IDAP REPORT

Property:	2-4 Homebush Road STRATHFIELD Lot: 17 DP: 128830 DA2021.319
Proposal:	Alterations and additions to an existing ground floor space within a residential flat building for the fit out and use as a medical centre, associated landscaping and carparking.
Applicant:	M Pisarkiewicz
Owner:	M Farag & A Zaki
Date of lodgement:	7 December 2021
Notification period:	14 December – 25 January
Submissions received:	1 submission with 6 signatories
Assessment officer:	J Gillies
Estimated cost of works:	\$115,000.00
Zoning:	R3-Medium Density Residential - SLEP 2012
Heritage:	No
Flood affected:	No
Is a Clause 4.6 Variation Proposed:	No
RECOMMENDATION OF OFFICER:	Approval

Figure 2 – Proposed Alterations and Additions

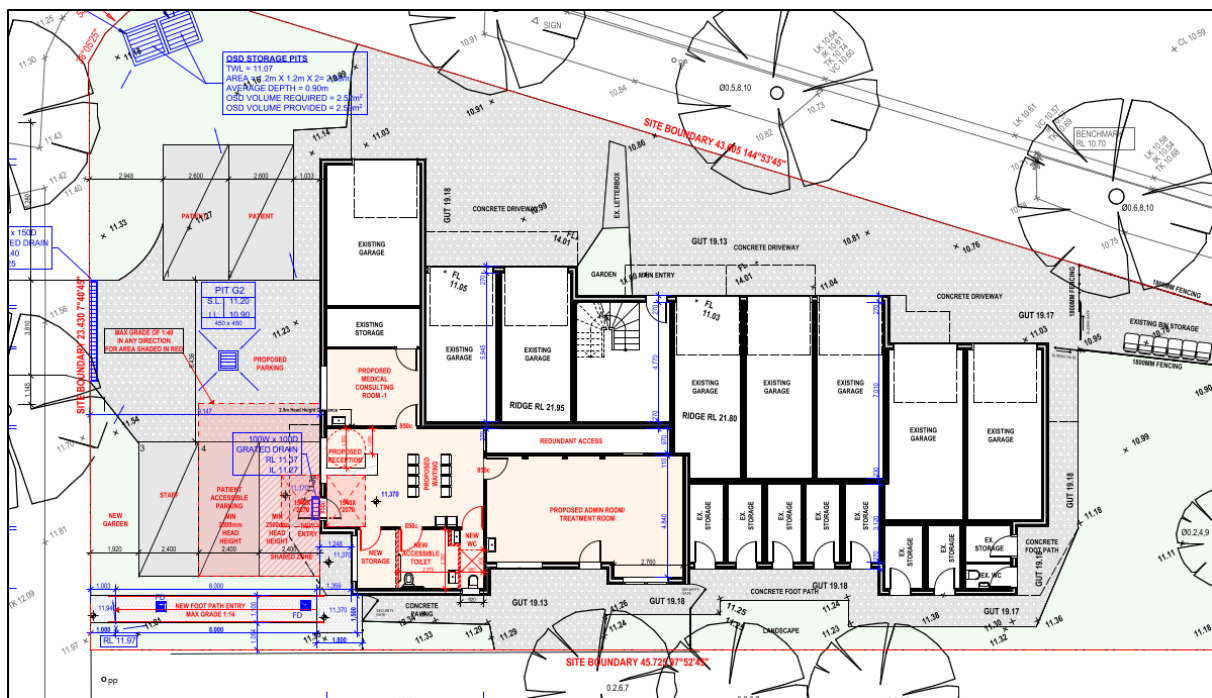
Figures 2 and 3 below illustrate the alterations and additions and proposed landscaping works.

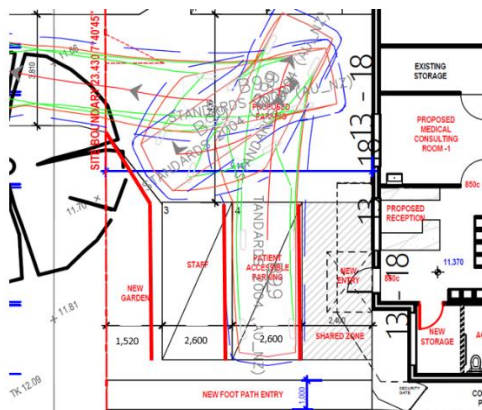
The geometric layout of the proposed off street parking basement parking shows a very tight maneuvering swept path into the Patient Accessible Parking space.

Comment - The new garden to be reduced in width by 400mm and increase the width of both the Staff and the Patient Accessible parking spaces to 2600mm. see below.
